Origination Form
Proposed Revisions to a Standard Plans Index

Originator:	Turley, Joshua	Index Number:	455-031
Date:	5/15/2025	Sheet Number(s):	Sheet 1
E-mail:	Joshua.Turley@dot.state.fl.us	Index Title:	30" SQUARE PRESTRESSED CONCRETE PILE - HIGH MOMENT CAPACITY

DETAIL OF PILE COLLAR FOR HIGH MOMENT CAPACITY 30" SQUARE PRESTRESSED PILE - PILE SPLICE DETAIL-

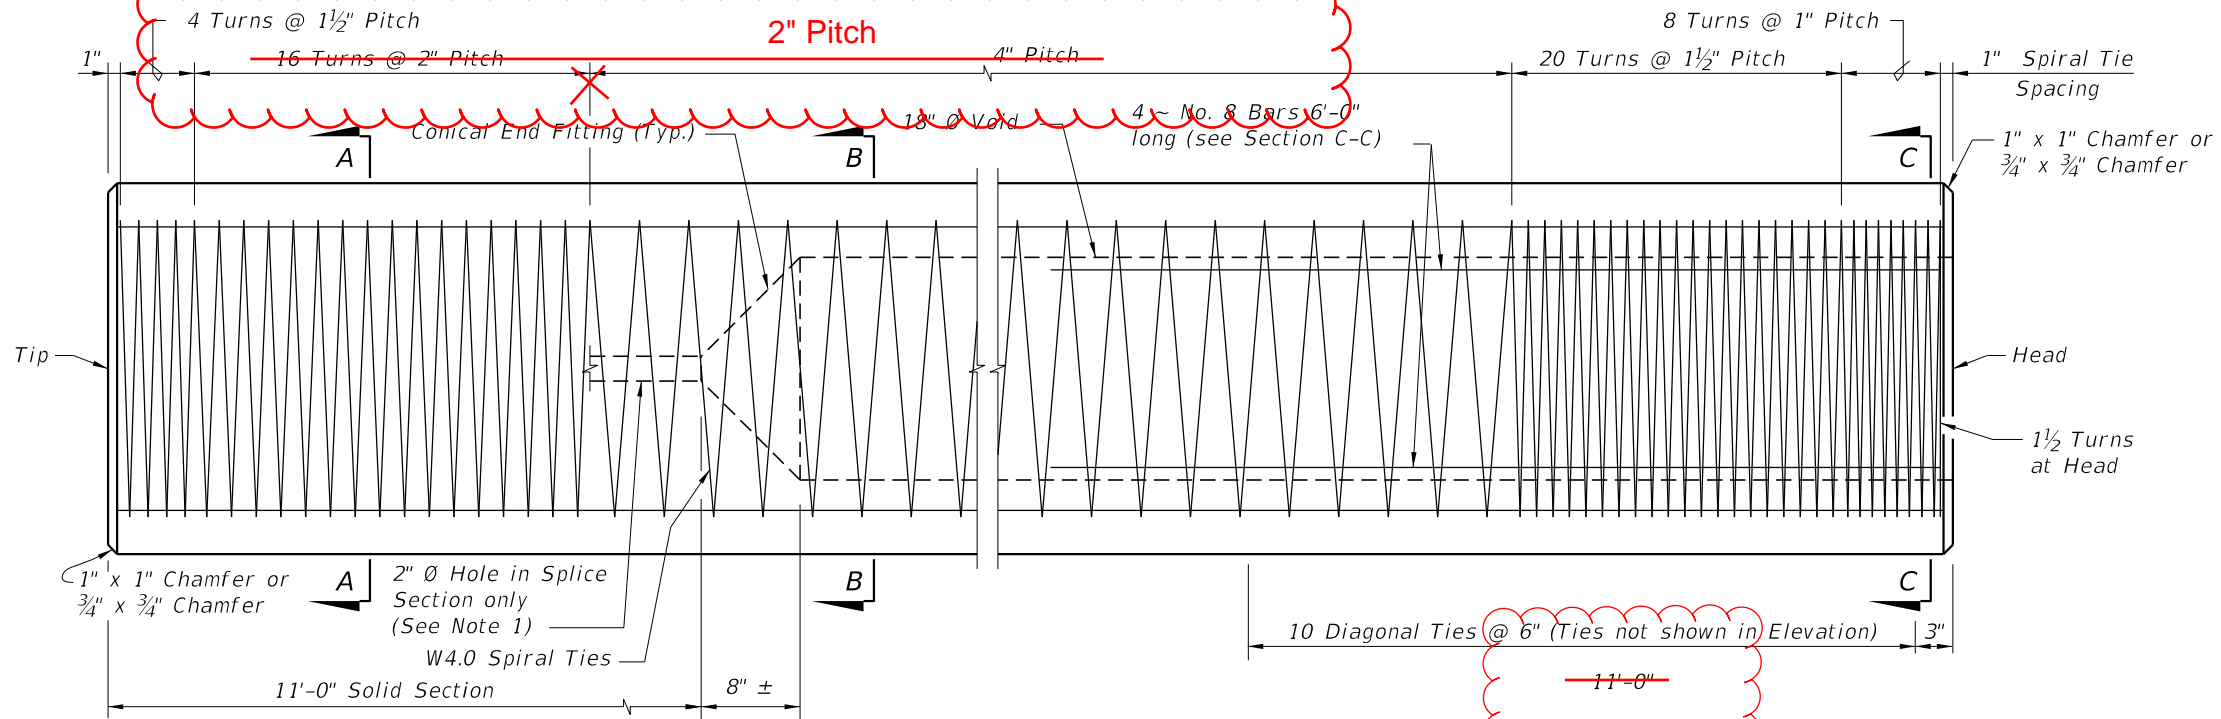
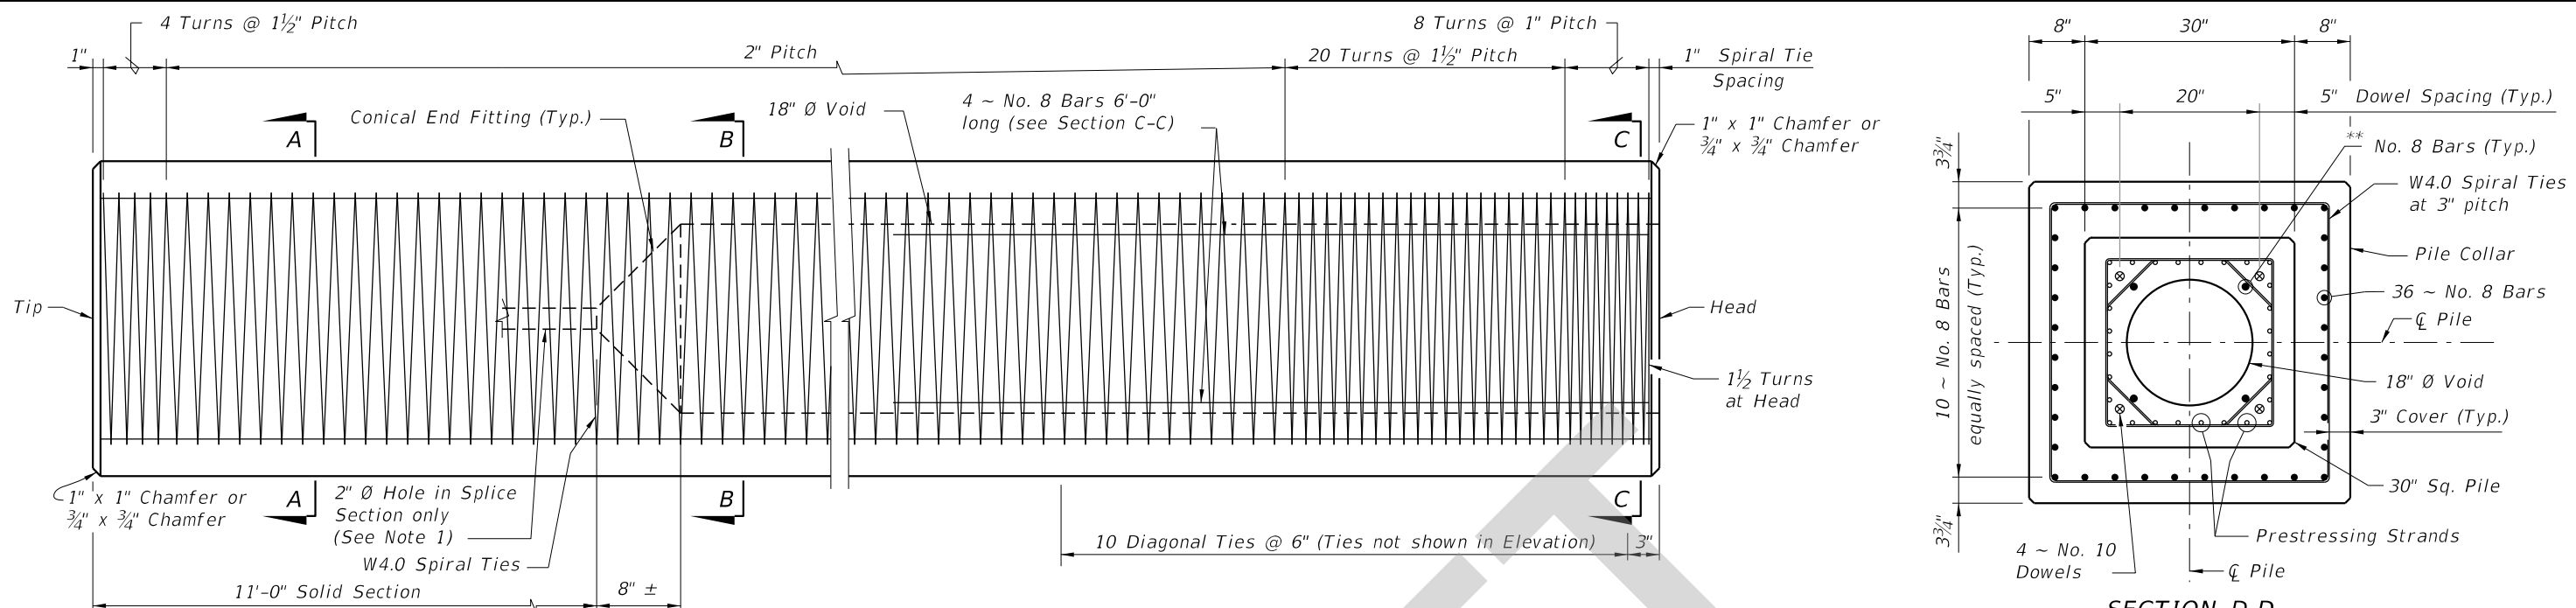
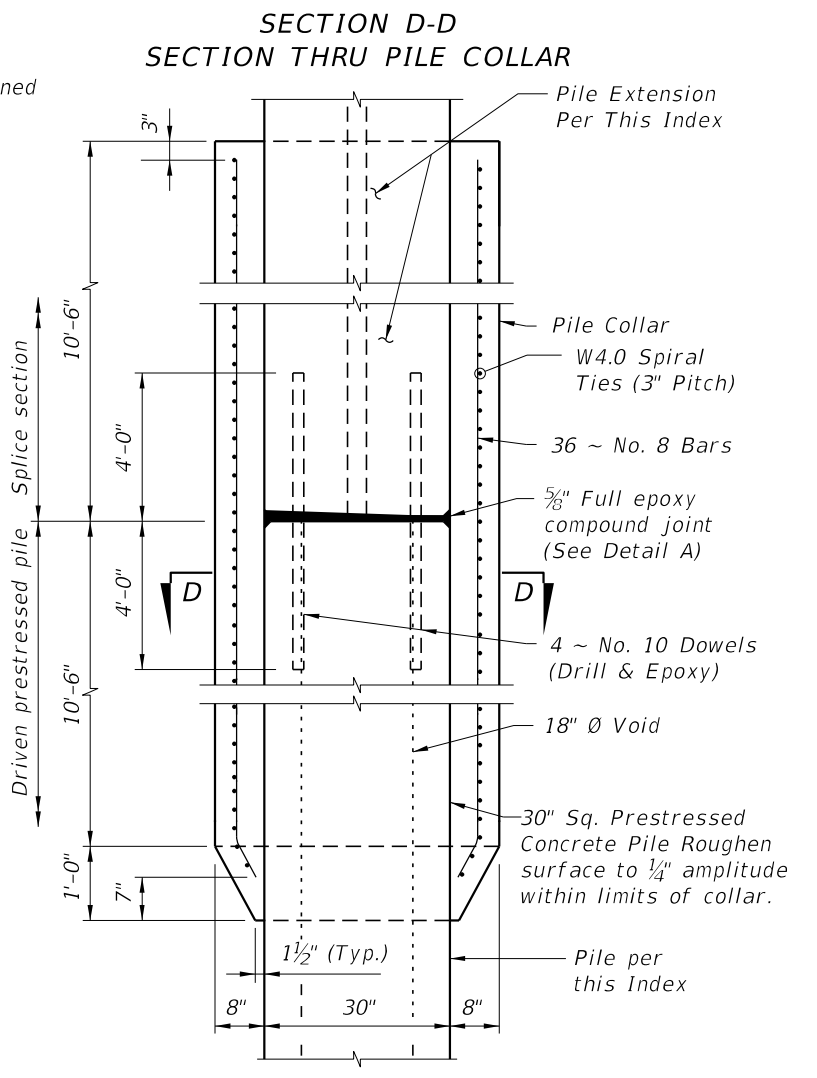
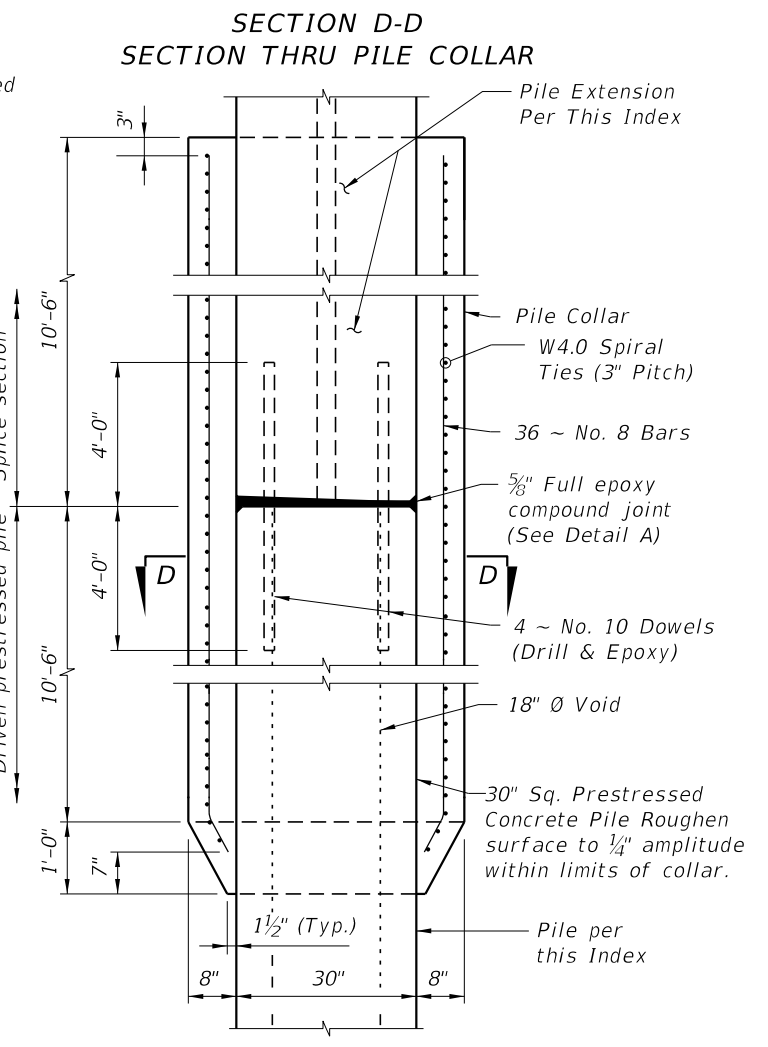
Sheet 1: Changed pitch spacing for spiral ties and removed errant 11' dimension which was a CAD error.

Vertical cracking has been observed in hollow core prestressed concrete piles, including 30-in. voided square HMC and conventional piles, and 60-in. hollow cylindrical piles, during installation and service. To address cracks frequently occur within the 4" stirrup pitch zone, a reduction in stirrup pitch to 2" is proposed to help mitigate cracking in these areas.
